A123 SYSTEMS JSP17-21

Consideration at the request of A123 Systems for approval of the revised Preliminary Site Plan, Phasing Plan and Stormwater Management Plan. The subject parcel is located in Section 15, West of Cabaret Drive and South of Twelve Mile Road and is zoned OST, Office Service Technology. The applicant is proposing to develop the 31.25 acre parcel with two buildings: one office/lab space of 128,936 square feet on the southern portion of the site (Phase 1) and the other as an assembly building of 53,469 square feet (Phase 2) including associated site improvements. Phase 1 would also include a temporary pad for a shipping container and nitrogen tank enclosure and a request for landbanked parking spaces.

PLANNING REVIEW

Revised Preliminary and Final Site Plan with Phasing

DRAWING NUMBER:
C-4.1

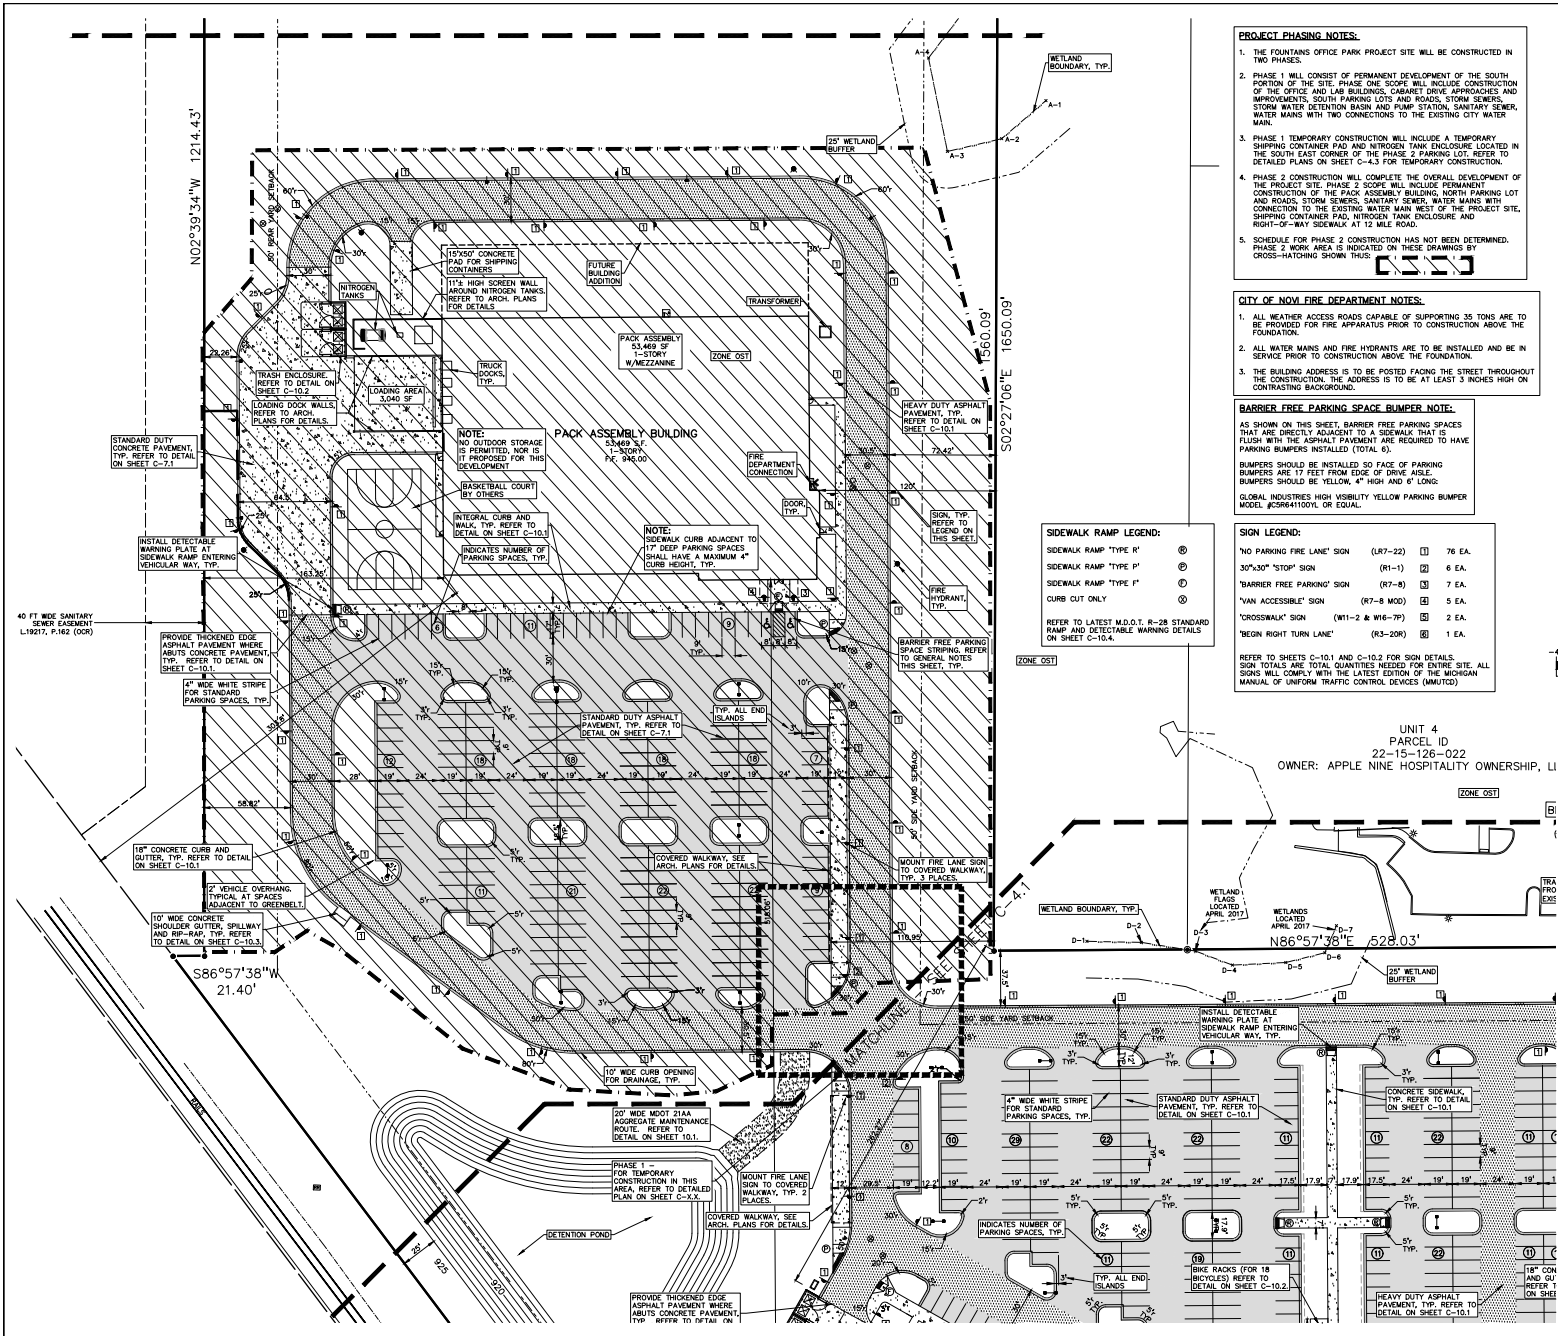
4. Flagpoles (Sec. 4.19.2.B): *Flagpoles require a building permit.*
5. Sidewalk on Twelve Mile Road: The applicant has proposed a sidewalk on Twelve Mile Road, as required. **The plans indicate this sidewalk will be provided in Phase 2, however the applicant should construct it in Phase 1.**
